## Summary for DRH18-00260

Rafanelli & Nahas – Scott Schoenherr, requests Design Review approval to Construct a ten story, approximately 181,000-square feet, office building and other site related improvements within the R- C-5DD (Central Business with Downtown Design Review Overlays) zone. The site is located within the heart of the downtown core. 11th Street and Idaho Street are designated as “Storefront” street frontages within the Downtown Boise Design Review Standards and Guidelines. The Idaho Street and 11th Street intersection is identified as a “Gateway and High Visibility Street Corner” in the Downtown Boise Design Review Standards and Guidelines.

# Planning Division Project Report

<b>File Number</b>	DRH18-00260
<b>Applicant</b>	Rafanelli & Nahas – Scott Schoenherr
<b>Property Address</b>	1118 West Idaho Street
<b>Public Hearing Date</b>	July 11, 2018
<b>Heard by</b>	Design Review Committee
<b>Design Review Planner</b>	Andrea N. Tuning
<b>Design Review Supervisor</b>	Hal Simmons

1 ARCHITECTURAL SITE PLAN  
1" = 20'-0"

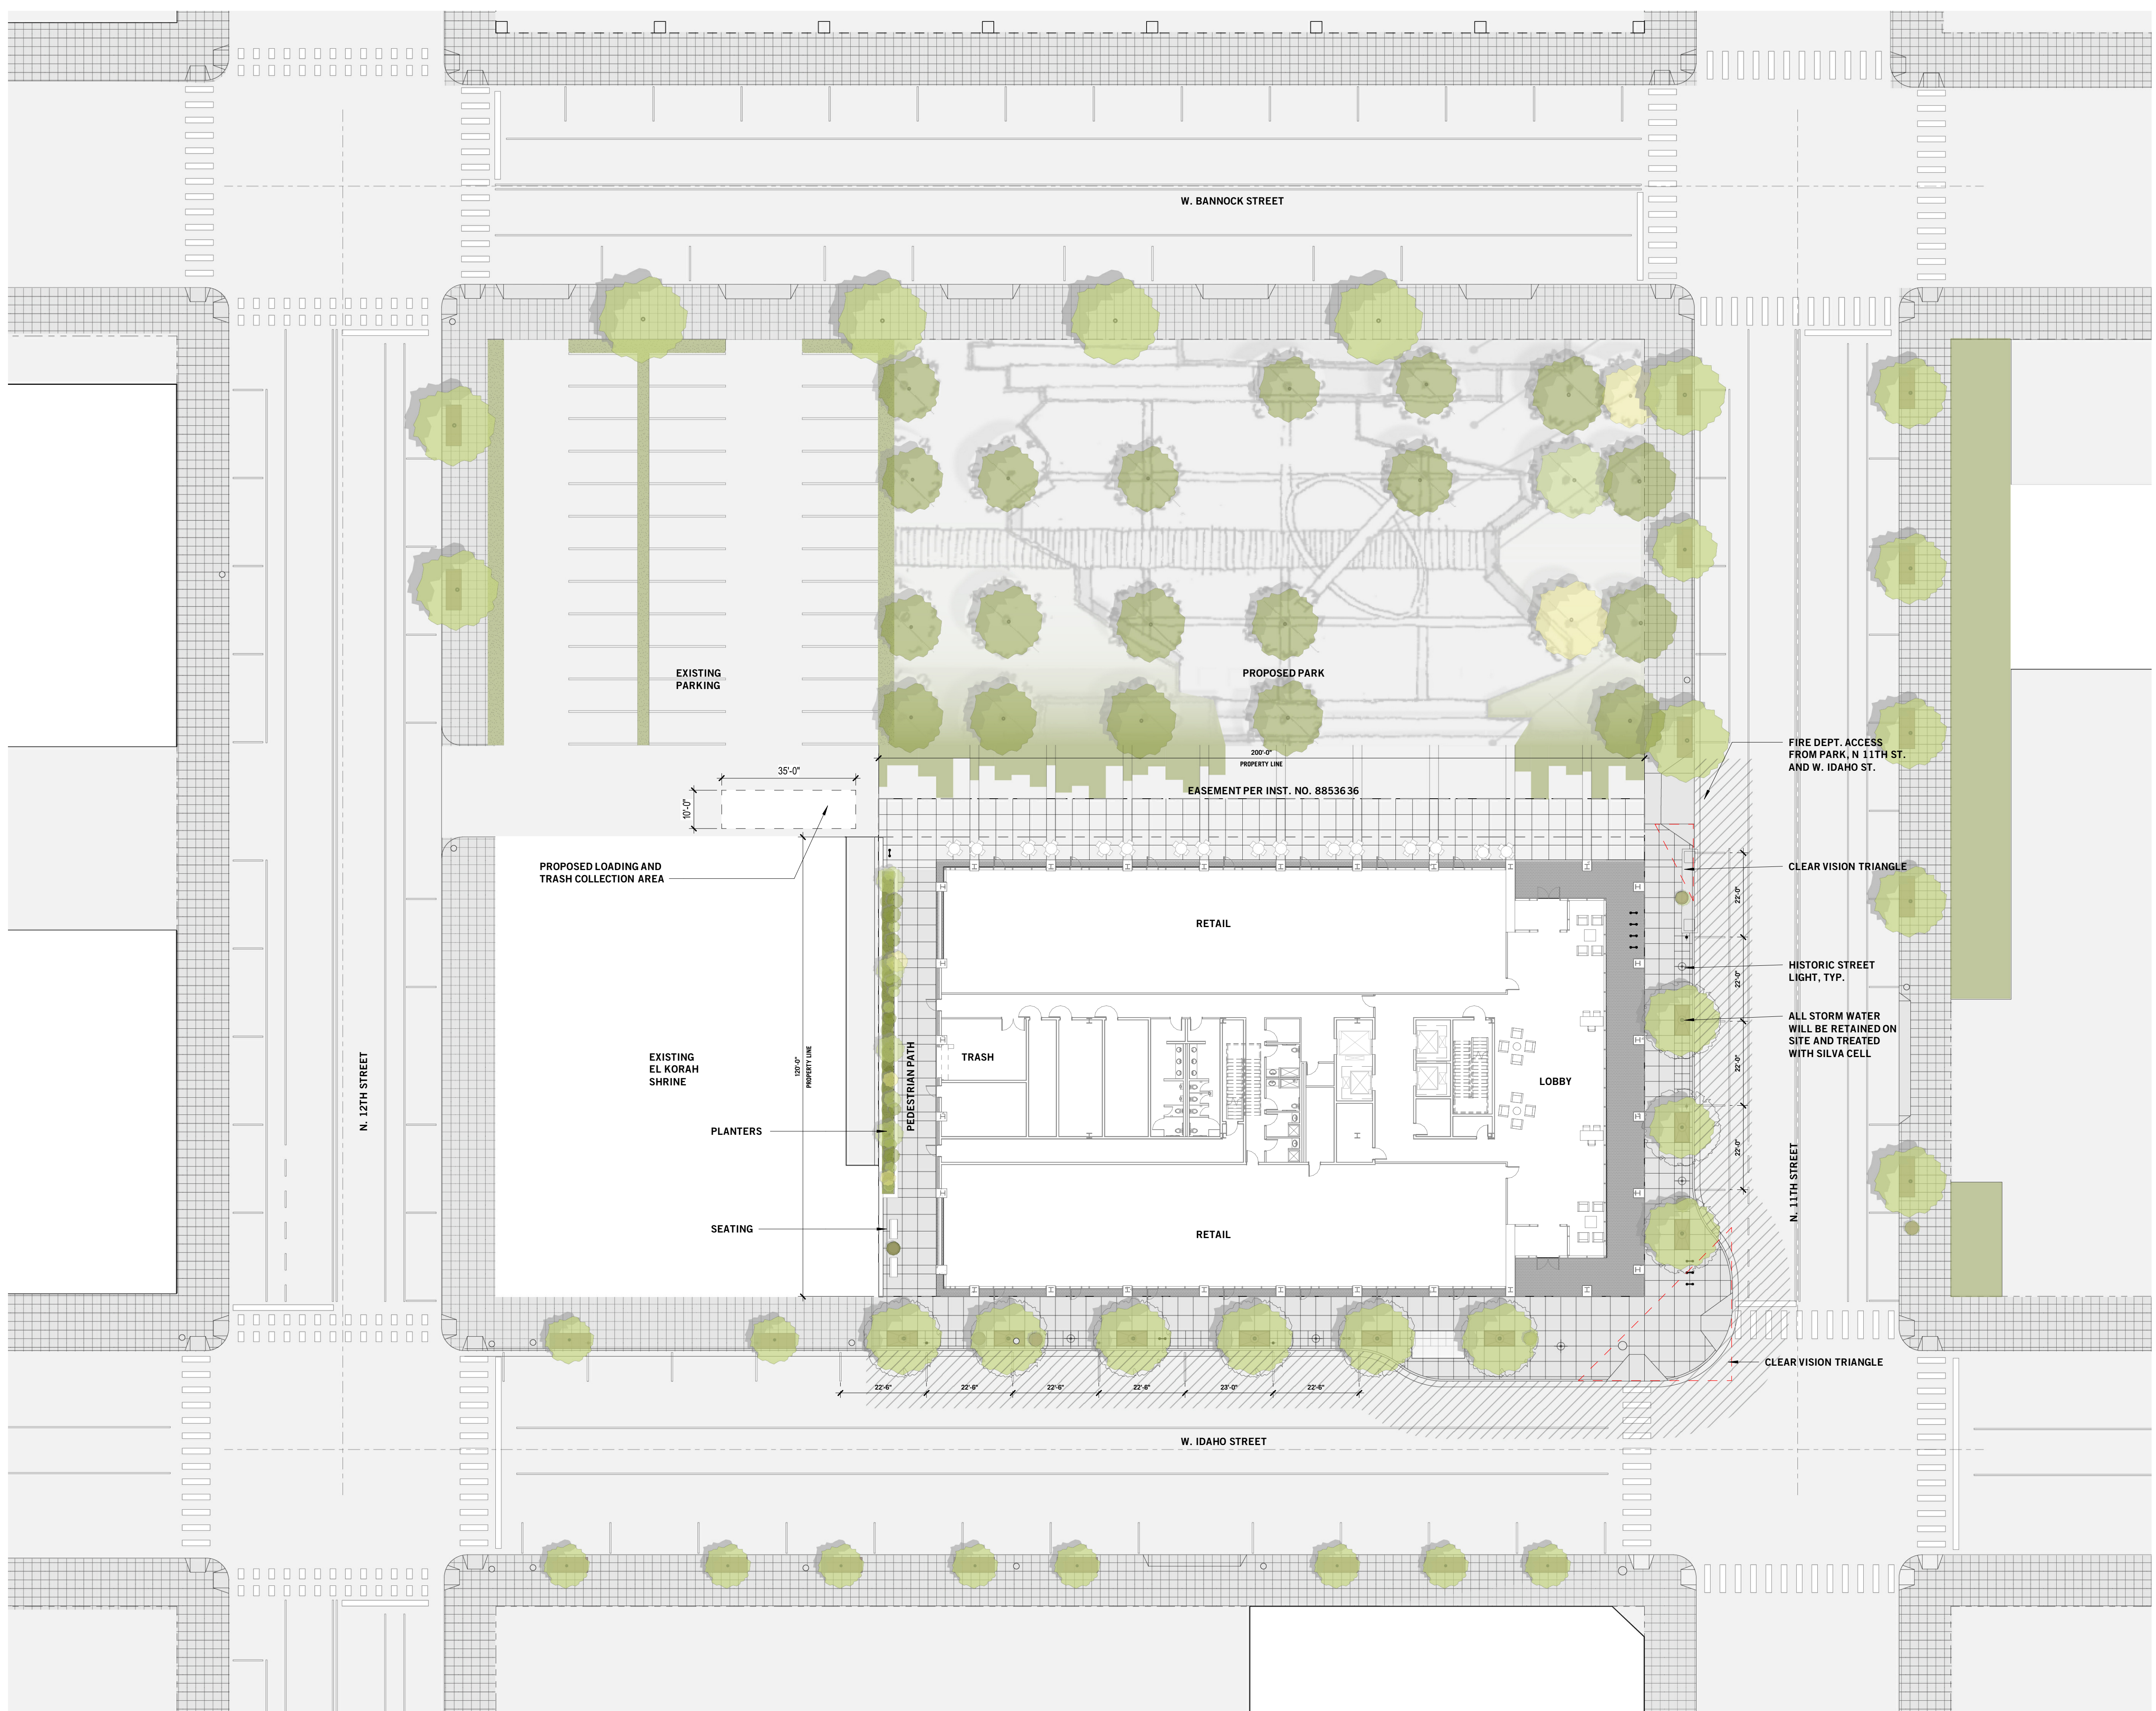
The Downtown Streetscape Standards identify 11th Street and Idaho Street as an "Urban Concrete" streetscape typology. This typology requires the applicant provide an 8-inch concrete curb zone, a 4-foot wide furnishing zone, and an 8-foot wide sidewalk. The furnishing zone should contain Class II street trees located within 4' x 8' tree grates spaced approximately every 30-feet and appropriately located historic street lights that are spaced approximately 60-feet on center. The applicant is proposing to construct Idaho Street with an 8-inch concrete curb zone, a 4-foot wide furnishing zone and a 9-foot 4-inch pedestrian zone. There are 6 new Sweetgum trees that are planted within 4-foot by 8-foot tree grates and silva cells that are spaced every 33-feet on center. There are 3 proposed historic street lights proposed to be located 66-feet on center adjacent to the site. The applicant is proposing to construct 11<sup>th</sup> Street with an 8-inch concrete curb zone, a 4-foot wide furnishing zone, and a 7-foot 4-inch pedestrian zone. There are 3 new Honeylocust trees that are planted within 4-foot by 8-foot tree grates and silva cells that are spaced every 28-feet on center. There are 2 proposed historic street lights proposed to be located 58-feet on center adjacent to the site. While the pedestrian zone on 11<sup>th</sup> Street is less than 8-feet as required by the Downtown Streetscape Standards, the Design Review Division recommends approval of this modification due to the fact there is a 10-foot pedestrian space adjacent to the east elevation located between the pedestrian zone and the building face. This will provide additional space for pedestrians utilizing 11<sup>th</sup> Street.

The on-site pedestrian network will build upon the sidewalks and streetscapes provided on the 11th Street and Idaho Street and will include a pedestrian walkway between the new building and the existing El Korah building to the west. This will provide access to the new Boise City park from Idaho Street and will create a small seating area in the southwest corner of the site. The applicant will also be constructing a pedestrian pathway along the north side of the building adjacent to the future park. This area will create outdoor dining opportunities, pedestrian connectivity from 11<sup>th</sup> Street to 12<sup>th</sup> Street and will maintain the underlying easements that were retained when the alley was vacated. There are also pedestrian courtyards that are nestled under the building on Idaho Street and 11<sup>th</sup> Street. With the proposed modifications, the on-site pedestrian facilities will provide a well-connected sidewalk network extending throughout the site, on Idaho Street and on 11<sup>th</sup> Street.

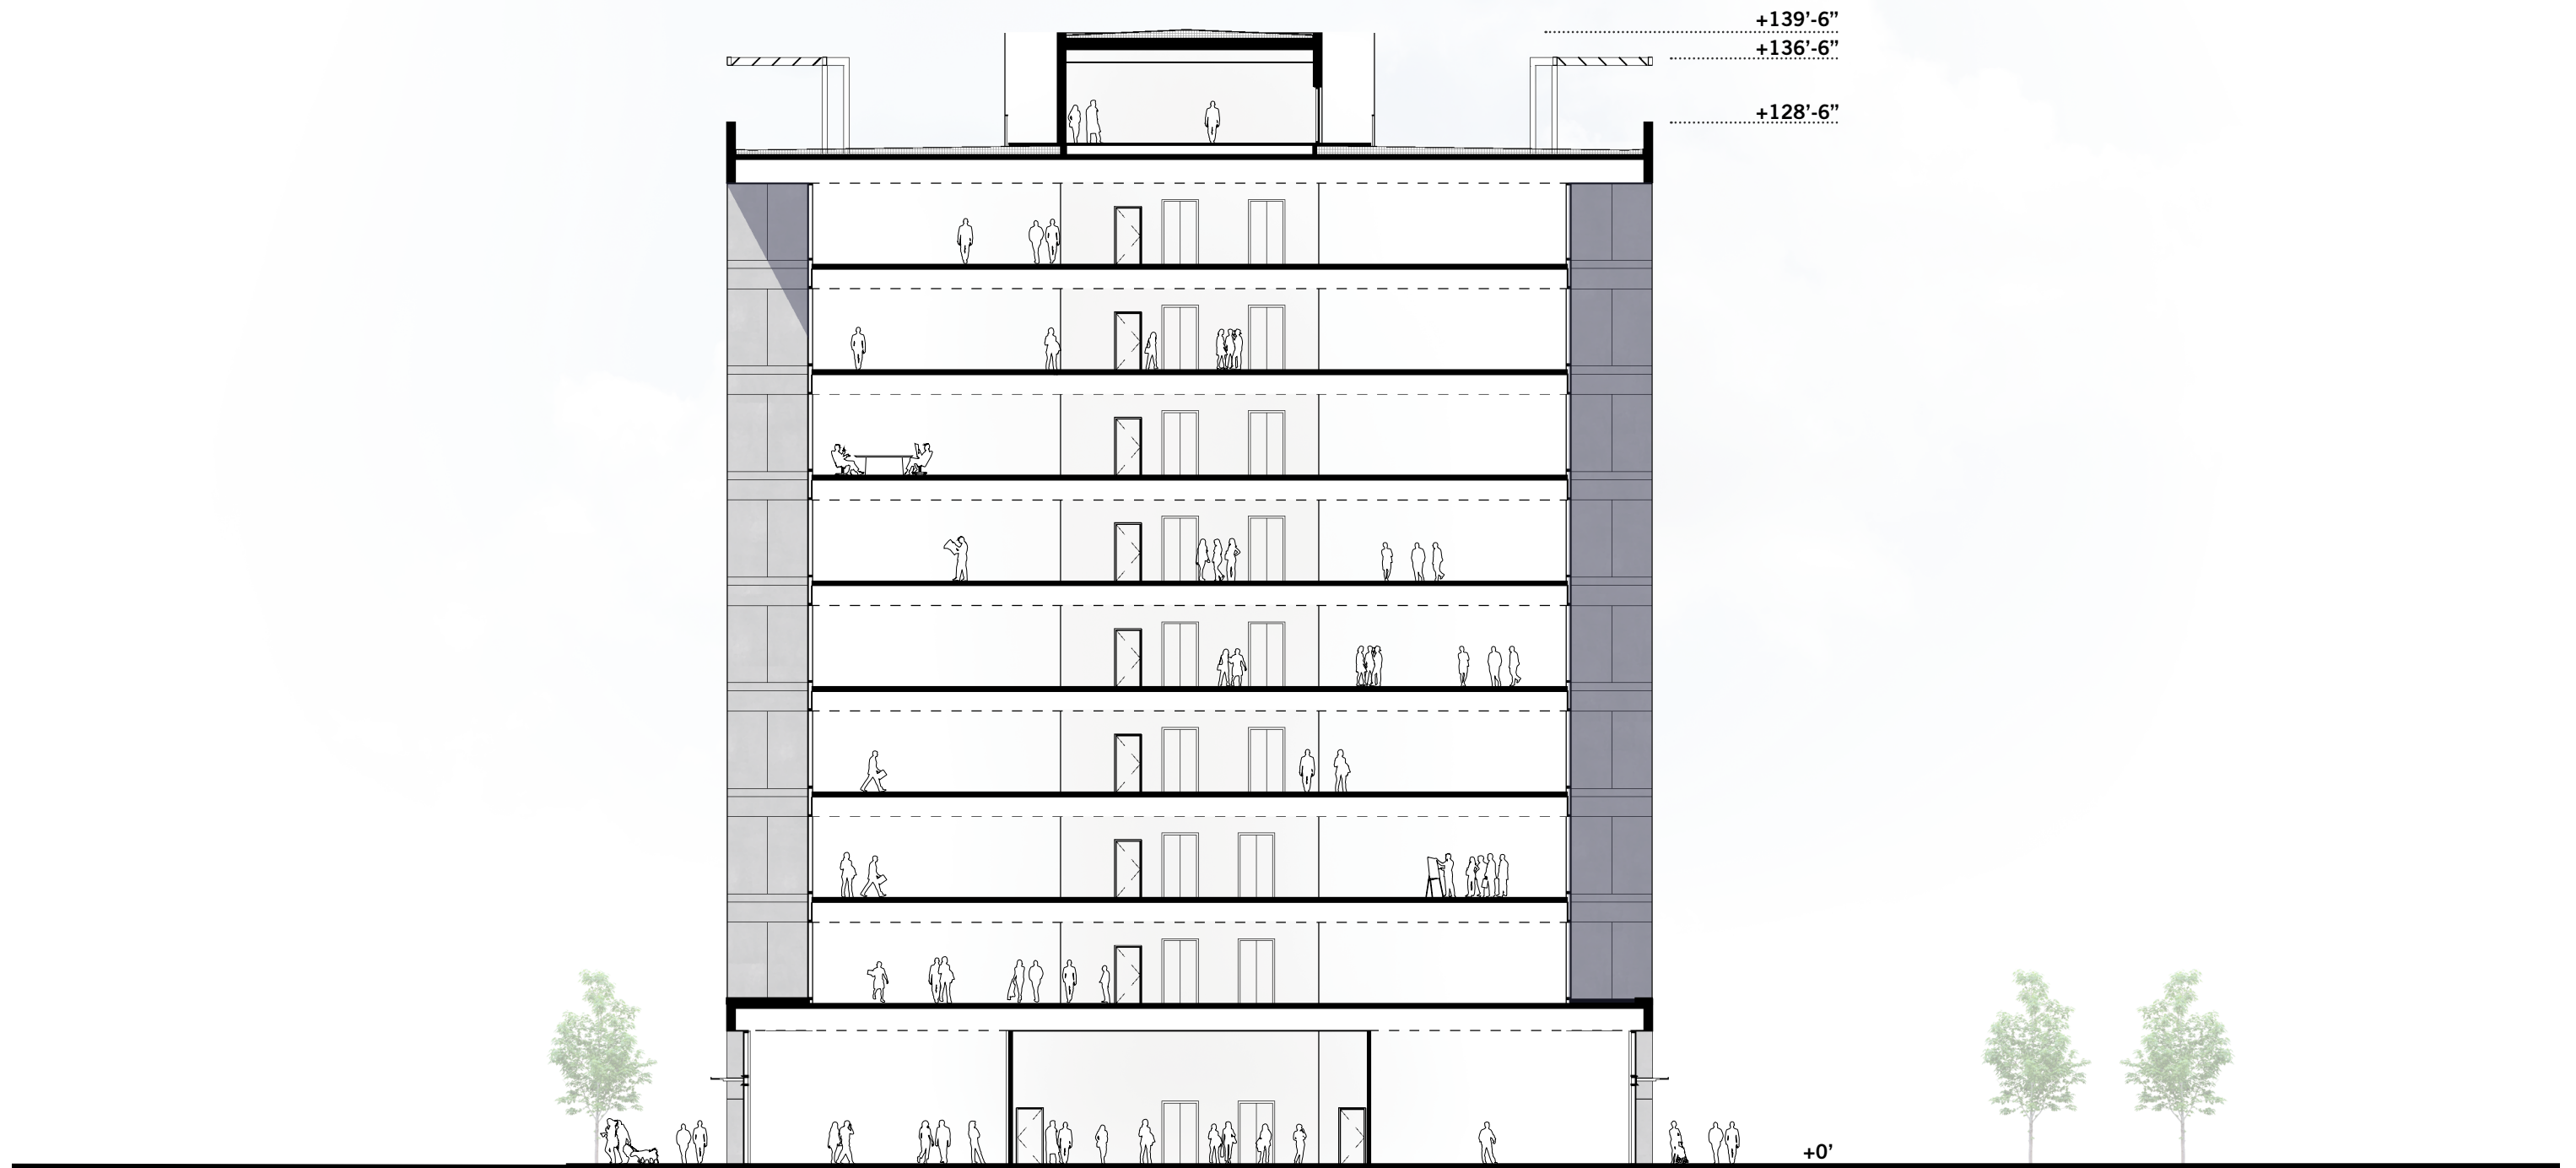
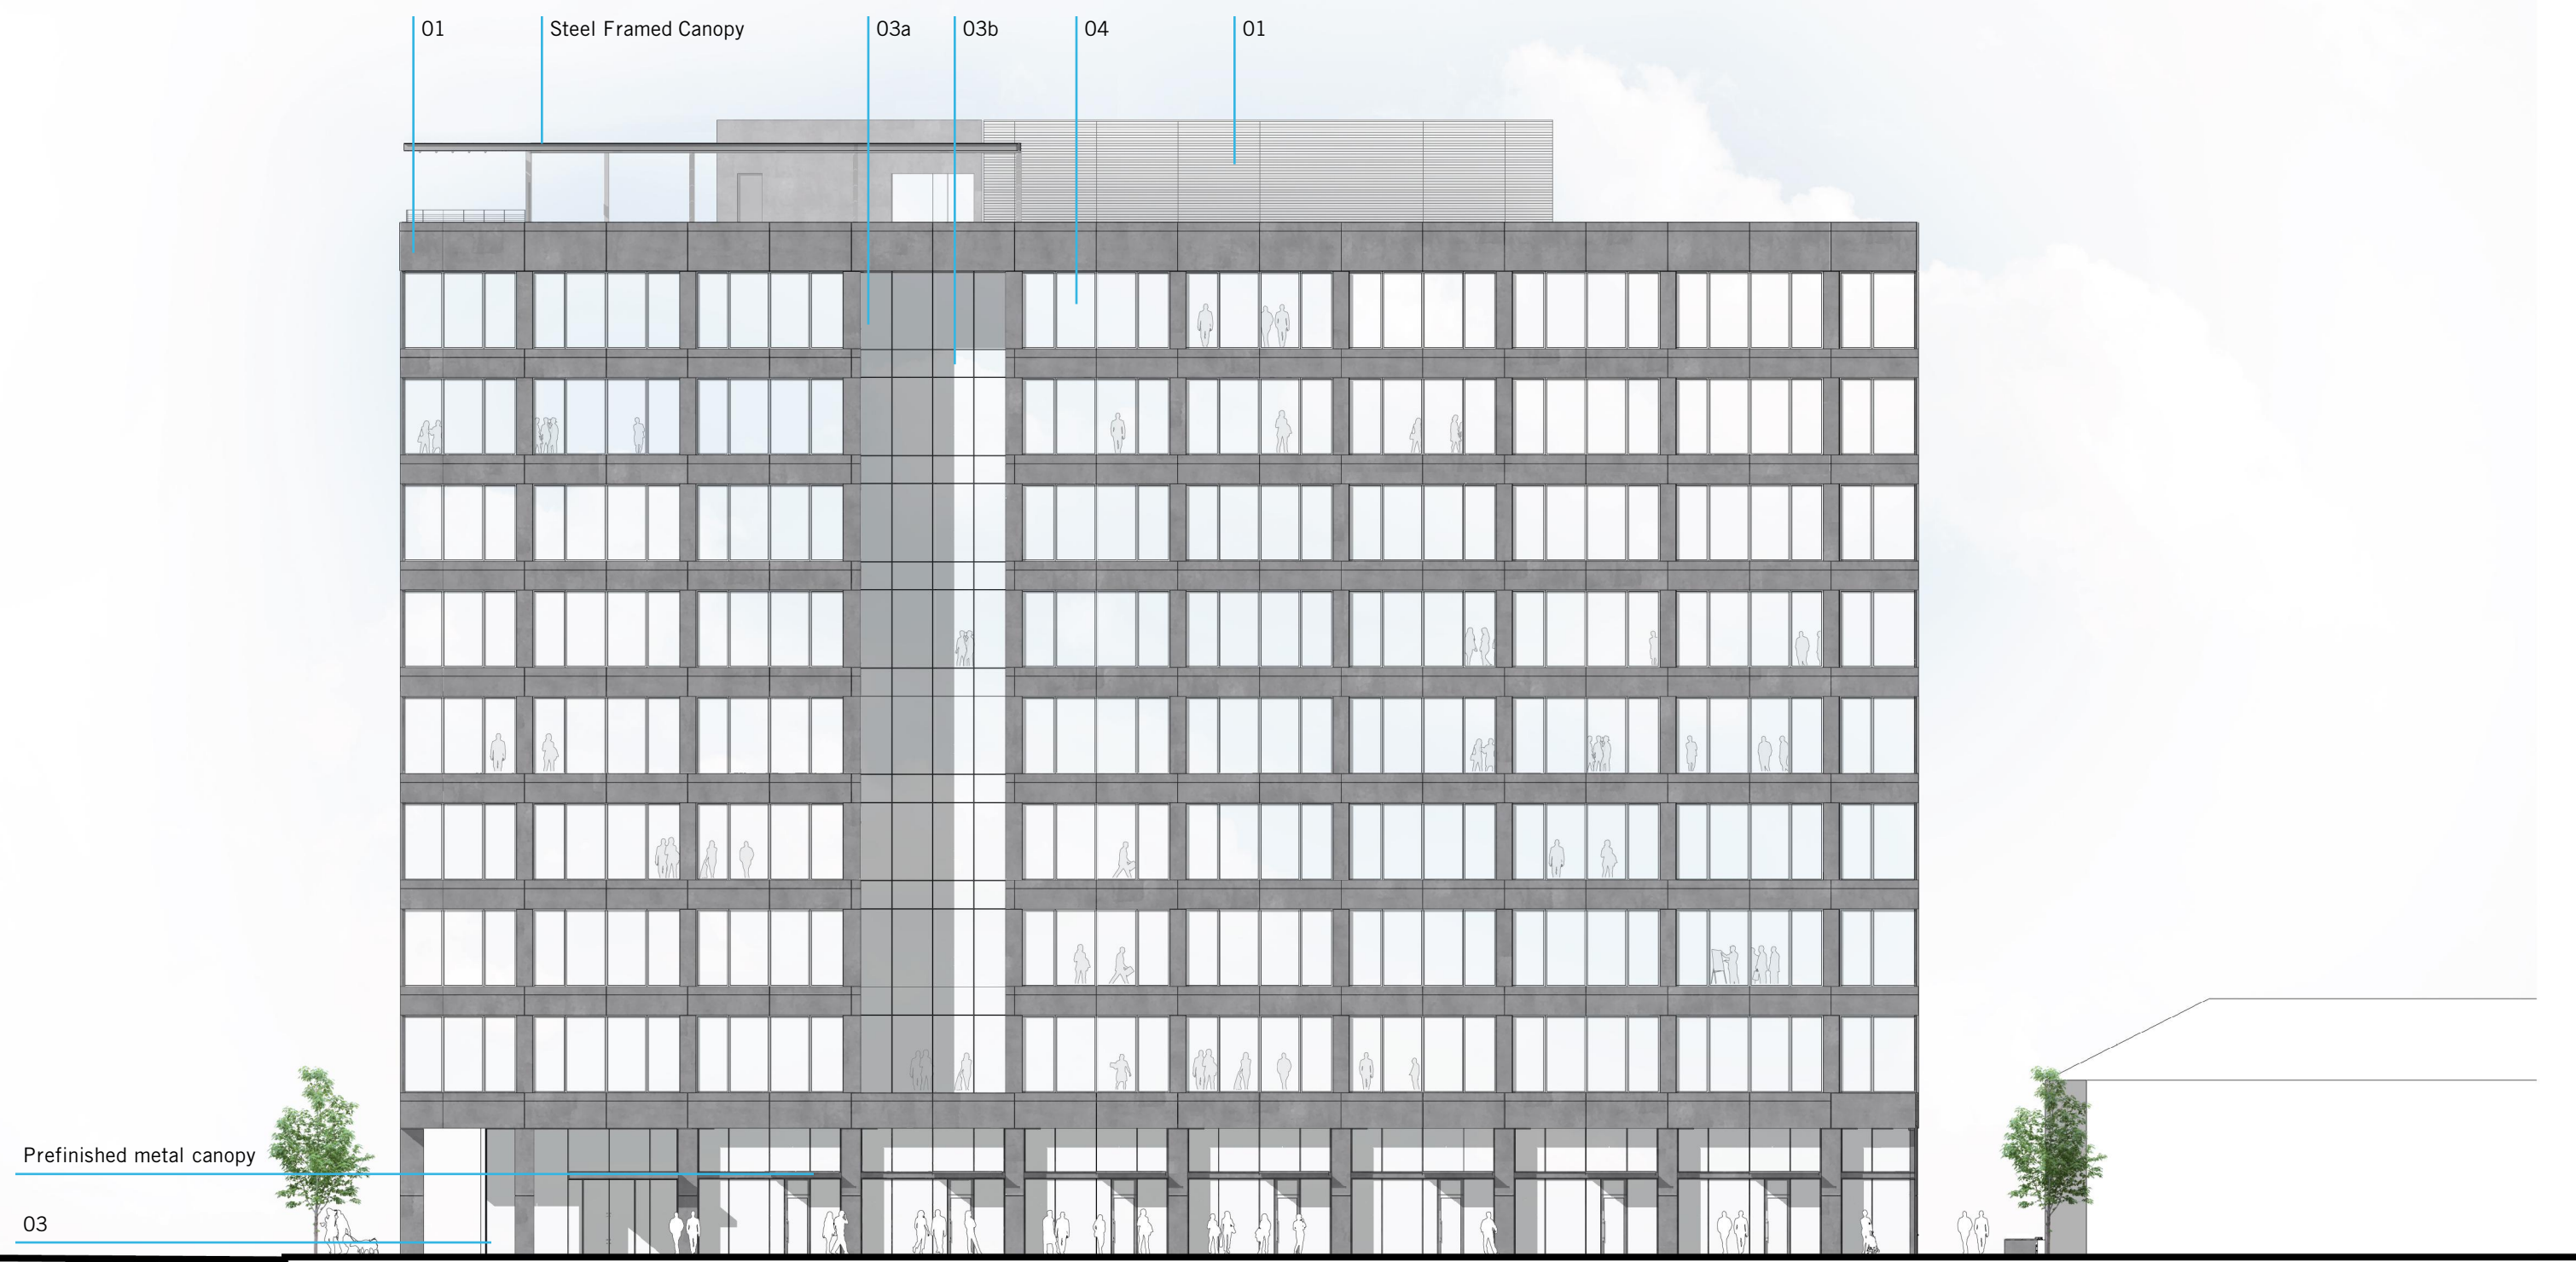
The one modification that will be required on the structure is the enlargement of the canopies at the ground floor. The proposed structure presents 4-foot deep canopies however the Downtown Boise Design Review Guidelines require weather protection that is a minimum of 5-feet in depth.
